Tesla, Inc. Service Bulletin		<h1>Inspect and Rework Instrument Panel</h1>	
SB-25-14-002 January 9, 2026		R1			
Classification		Section/Group		Mobile Service	Configuration
Campaign Bulletin		14 - Instrument Panel		Can Perform (where permitted)	All
Model	Model Year	Country/Region		Build Location	
Model 3	2024–2026	Europe, Middle East		Giga Shanghai	
Model Y	2025–2026			Giga Berlin	
The model(s) and model year(s) listed are a general approximation of the affected VIN list. Refer to the VIN/Bulletin Tracker or Customer/Vehicle profile to determine applicability of this bulletin for a particular vehicle.

This Service Document supersedes SB-25-14-002, dated September 13, 2025. This new revision, R1, adds 2025+ Model Y vehicles. Each content change is marked by a vertical line in the left margin. Discard the previous version and replace it with this one.

Figure 1

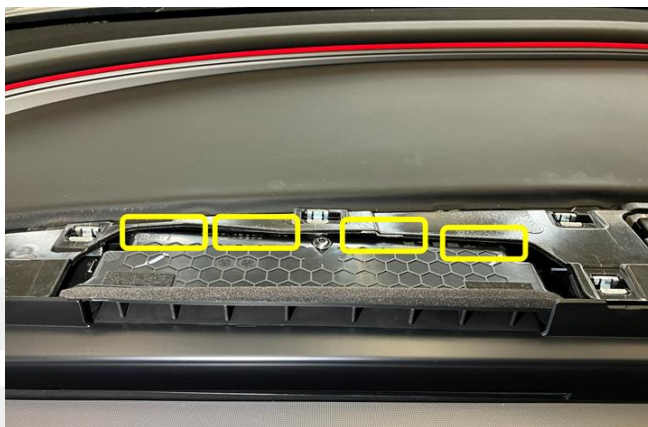
1. Remove the Instrument Panel Float Wing (refer to Service Manual procedure 1405020522, [Model 3](#); [Model Y](#)).
2. Cut 4 cm long pieces of foam tape (x4), and apply the foam tape to the illustrated areas between the instrument panel and the LH air vent assembly (Figure 1).
